**SUBJECT:** NuScale Power, LLC Response to NRC Request for Additional Information No. 270 (eRAI No. 9185) on the NuScale Design Certification Application

NuScale Response to NRC Request for Additional Information eRAI No. 9185

**NRC Question No.:** 02.03.04-1

Figure 2.3-2: Source to Control Building Door Distances

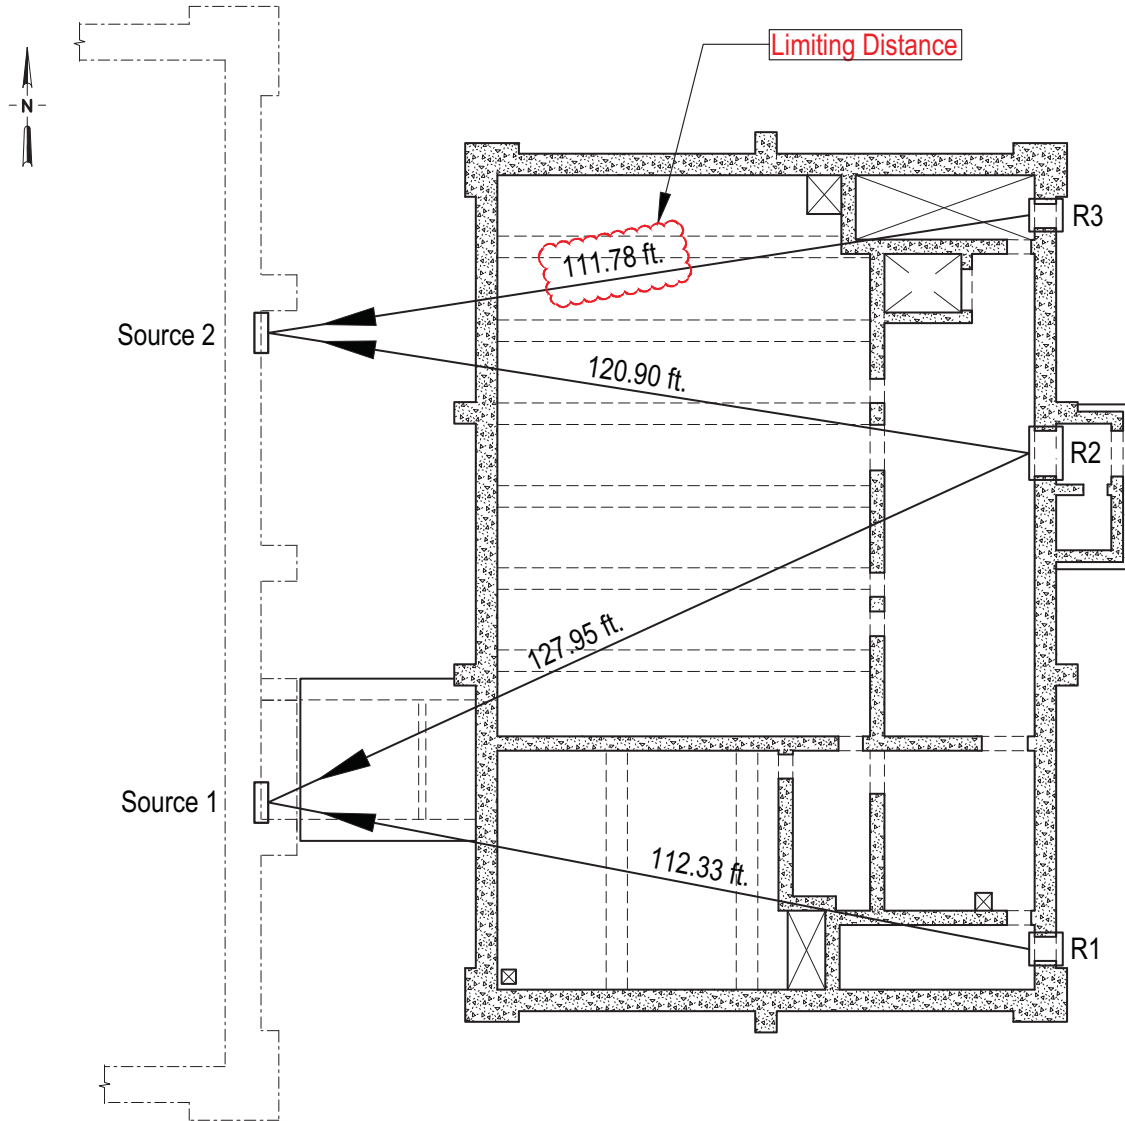
- a. Please revise the DCA FSAR to include all the NuScale nuclear plant configuration data required by COL applicants to perform atmospheric dispersion modeling (e.g., release heights, intake heights, building area).
- b. Please revise the directions shown in NuScale DCA FSAR Tier 2, Figures 2.3-2 and 2.3-3 from "source to receptor" directions to "receptor to source" directions.
- c. Please provide the basis that supports NuScale's position that the two source locations shown in NuScale DCA FSAR Tier 2, Figures 2.3-2 and 2.3-3 (e.g., the reactor building SE and NE single personnel doors) are the limiting source locations for all radiological accidents evaluated in the NuScale DCA FSAR.

b. FSAR Tier 2, Figures 2.3-2 and 2.3-3 are revised as requested, as shown in the attached markup. Note that the degrees are no longer shown. This is because the degree input to NARCON is based on the angle between the source and the receptor in relation to the true north which the weather data is based on. Since the layout of the buildings in the FSAR are in relation to an arbitrary "site north" which may or may not align with the as constructed plant's orientation to true north, this NARCON input can not be generically stated and the COL applicant will have to establish the correct input to NARCON if they have to redo the control room dose analysis.

c. The two source locations shown in Figures 2.3-2 and 2.3-3 are the limiting source locations because they are the closest source locations to the main control room personnel doors and main control room HVAC intake. FSAR Tier 2, Section 2.3.4 has been updated as shown in the attached markup to clarify this.

The  $\chi/Q$  values used for evaluation of doses in the MCR and TSC are determined at the Control Building doors and HVAC inlet and are listed in Table 2.0-1. Figure 2.3-2 and Figure 2.3-3 show the path and distances from the Reactor Building release point to MCR door and HVAC inlet. The two source locations shown in Figure 2.3-2 and Figure 2.3-3 are the limiting source locations because they are the closest source locations to the main control room personnel doors and main control room HVAC intake. Assumptions for release point characteristics used for the  $\chi/Q$  calculations are ~~also~~ listed in ~~Table 2.0-1.~~ Table 15.0-20.
